Project	<b>IEEE 802.16 Broadband Wireless Access Working Group</b> < <a href="http://ieee802.org/16">http://ieee802.org/16</a> >	
Title	<b>Definition of valid DL-MAP/DCD in MAC synchronization</b>	
Date Submitted	<b>2005-03-14</b>	
Source(s)	Donald Stevenson, Rainer Ullmann Wavesat Inc. 1375 Trans-Canada Highway, Suite 300 Dorval, Quebec, Canada, H9P 2W8	Voice: +1 514 684-0200 x321 Fax: +1 514 684-0211 <a href="mailto:rullmann@wavesat.com">[mailto:rullmann@wavesat.com]</a>
Re:	Supporting document for Letter Ballot #17 comment	
Abstract	The definition of achieving MAC synchronization is based on the concept of valid DL-MAP/DCD messages without properly specifying what that actually means.	
Purpose	Correction to be included into P802.16-2004/Cor1-D1	
Notice	This document has been prepared to assist IEEE 802.16. It is offered as a basis for discussion and is not binding on the contributing individual(s) or organization(s). The material in this document is subject to change in form and content after further study. The contributor(s) reserve(s) the right to add, amend or withdraw material contained herein.

# Definition of valid DL-MAP/DCD messages in MAC synchronization

*Replace Figure 56 on page 170 in IEEE Std 802.16-2004 with the following:*

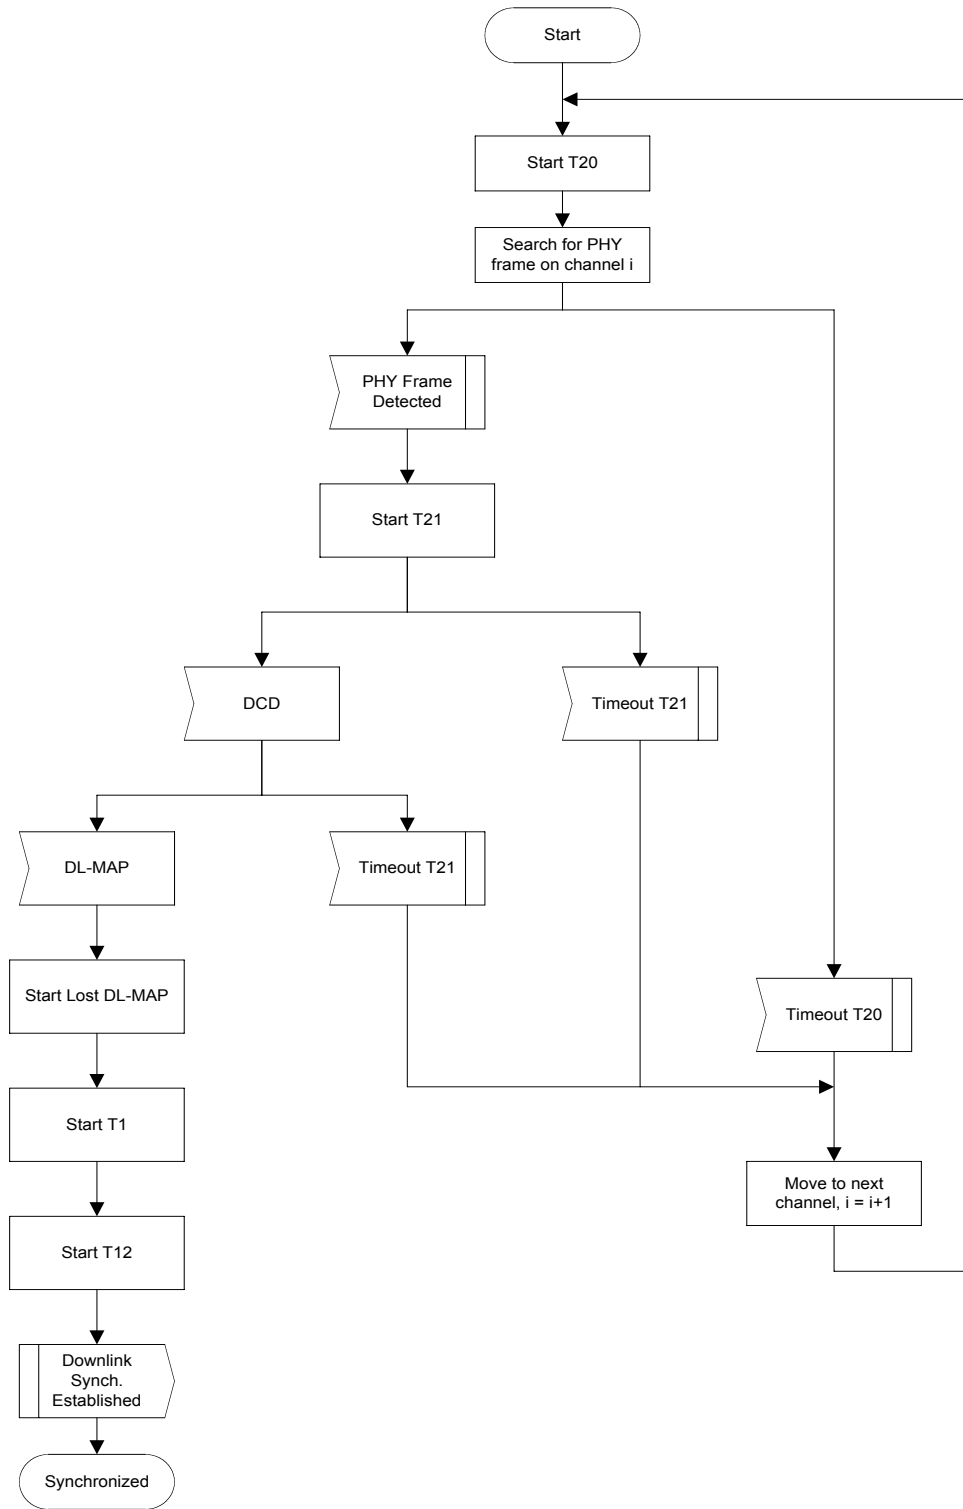
The text indicates that the SS achieves MAC synchronization once it has received at least one DL-MAP message. It also states that an SS MAC remains synchronized as long as it continues to successfully receive “valid” DL-MAP and DCD messages for its Channel. However, it is possible to receive a DL-MAP before a DCD message in which case there is no means to decode the DL-Burst Profiles contained in the DL-MAP. Therefore, is the DL-MAP received successfully and considered valid? If MAC synchronization and maintaining it is based on solely receiving a DL-MAP with correct CRC, then the SS might exit the MAC synchronization stage without proper understanding of the burst profiles and lacks the parameters to start initial ranging. If “valid” DL-MAP includes being able to understand all included parameters then a DCD message has to be received before the timeout condition for Lost DL-MAP occurs, otherwise the SS is forced to scan for another channel even though the current one was perfectly suitable (see Figure 57). However, this timeout condition might easily occur before the first DCD message is received (T1 >> Timeout Lost DL-MAP).

To avoid this, the Timeout Lost DL-MAP has to be started after a DCD has been received.

In order to clarify that to receive a DL-MAP successfully, all fields contained with the DL-MAP must be understood. To do this implies that the DCD and a DL-MAP must both be received before you can consider the MAC “synchronized”.

The MAC shall search for [a DCD MAC management message followed by the DL-MAP MAC management messages](#). The SS achieves MAC synchronization once it has received at least one [DCD message followed by a DL-MAP message and is able to decode the DL-Burst Profiles contained therein](#). An SS MAC remains in synchronization as long as it continues to successfully receive the DL-MAP and DCD messages for its Channel. If the Lost DL-MAP Interval (Table 342) has elapsed without a valid DL-MAP message or the T1 interval (Table 342) has elapsed without a valid DCD message, an SS shall try to reestablish synchronization. The process of acquiring synchronization is illustrated in Figure 56. The process of maintaining synchronization is illustrated in Figure 57.
